# Minutes of 74<sup>th</sup> PCC Meeting

**Date: 02.01.2019**  
**Eastern Regional Power Committee**  
**14, Golf Club Road, Tollygunge**  
**Kolkata: 700 033**

## **MINUTES OF 74<sup>TH</sup> PROTECTION SUB-COMMITTEE MEETING HELD AT ERPC, KOLKATA ON 19.12.2018 (WEDNESDAY) AT 10:30 HOURS**

# DR recorded at KTPP end during the first fault at 12:50 hrs

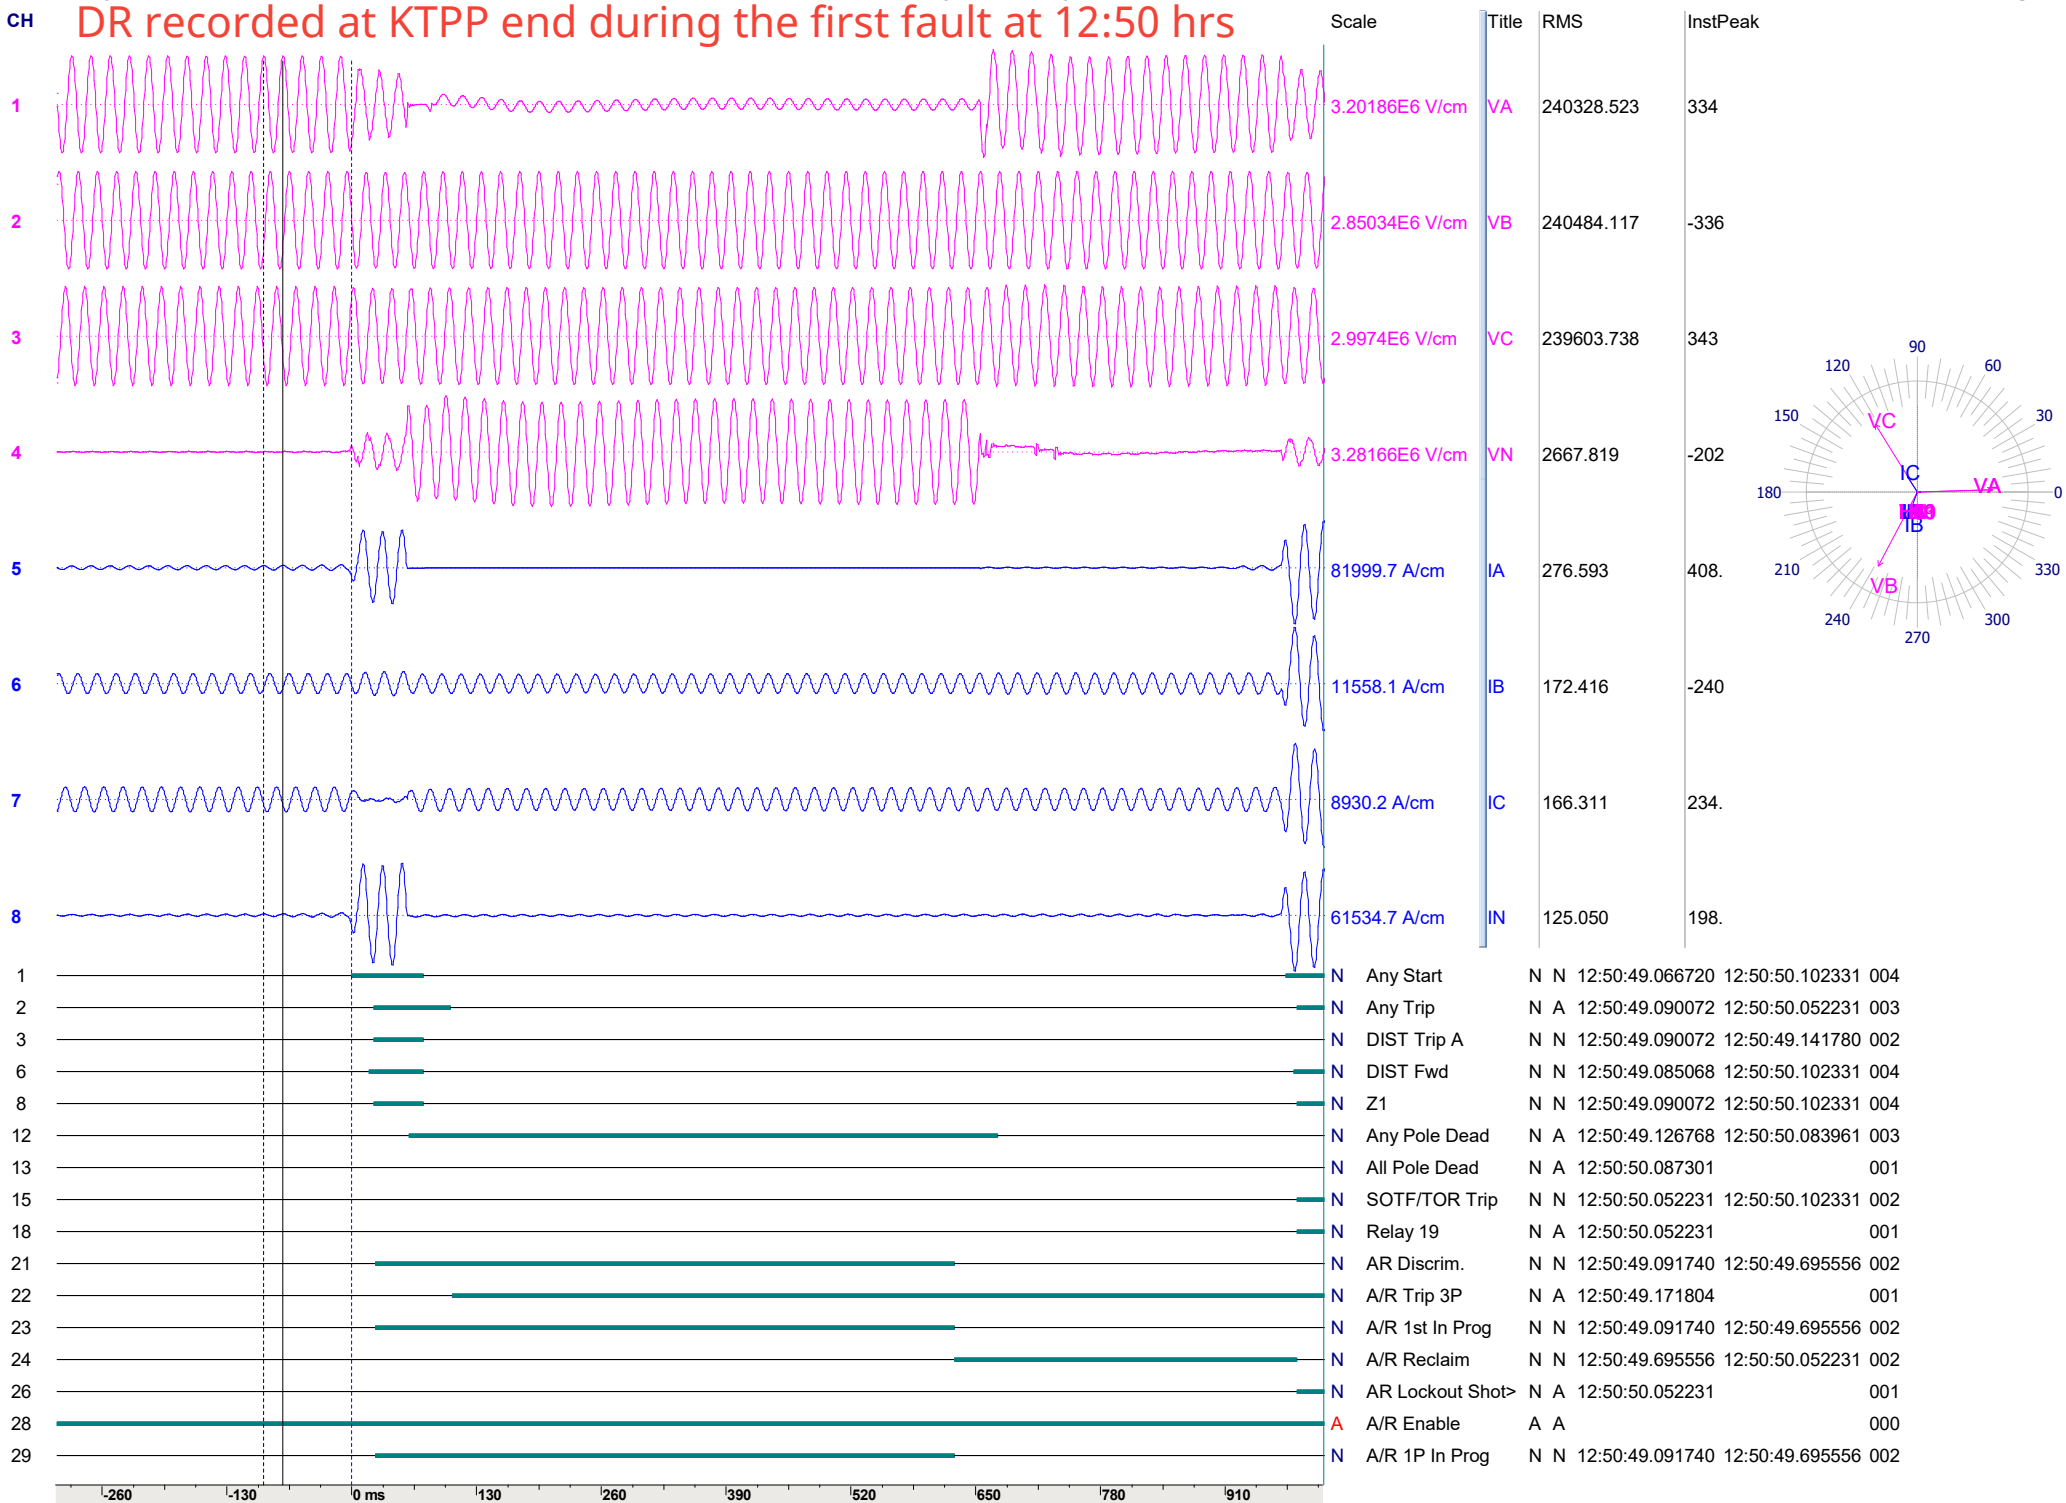
**Points of concern:**

1. DR installed at Kharagpur end is not time synchronised
2. Dead time at KTPP end (generating station) was 500 ms while dead time at Kharagpur end was more than 1000 ms. WBPDCCL has informed they have increased dead time at KTPP end to 900 ms after the incident. Kharagpur end dead time may be co-ordinated with KTPP end dead time.

*For fault at 12:50 hrs, PCC advised WBSETCL and WBPDCCL to coordinate autorecloser discrimination time with the dead time of circuit breaker.*
